SYSTEM/MODEL: TD-H/B

MODIFICATION: TD-1H with off-hook ringing

TD-1H/B WITH OFF HOOK CALL IN

TD-H/B Mod. #1298-1067 Sch #1440-1067

TD-1H/B Schematic Diagram

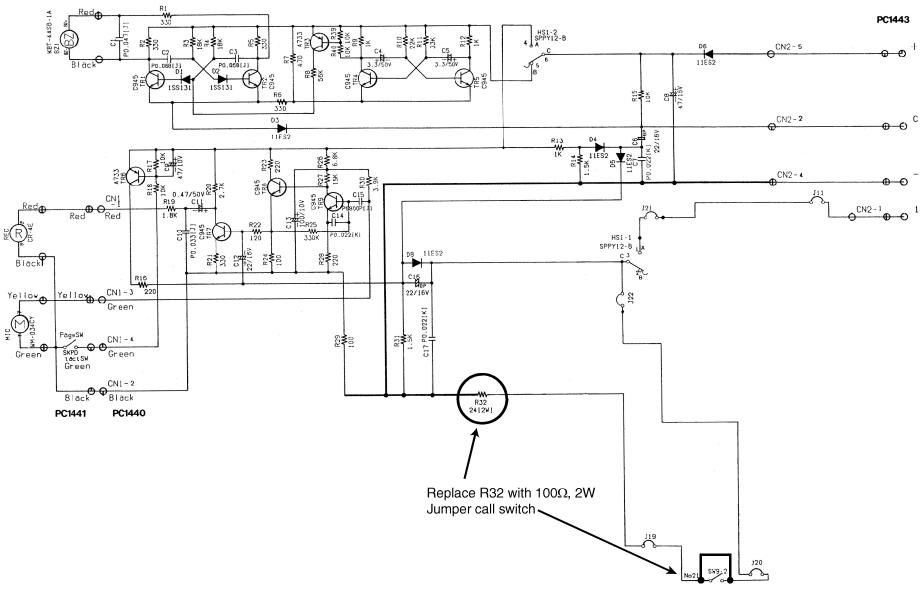
INSTR/OPERATIONS: 1. Remove and replace resistor R32 as shown on the schematic.

2. Install jumper across call switch as shown on schematic.

This modification will allow the opposite TD-1H/B phone to ring as soon as one of the handsets is picked up. The call tone will continue until the second handset is picked up or the first handset is hung up.

COMPONENTS REQUIRED: 1. Resistor: 100 ohm, 2 Watt
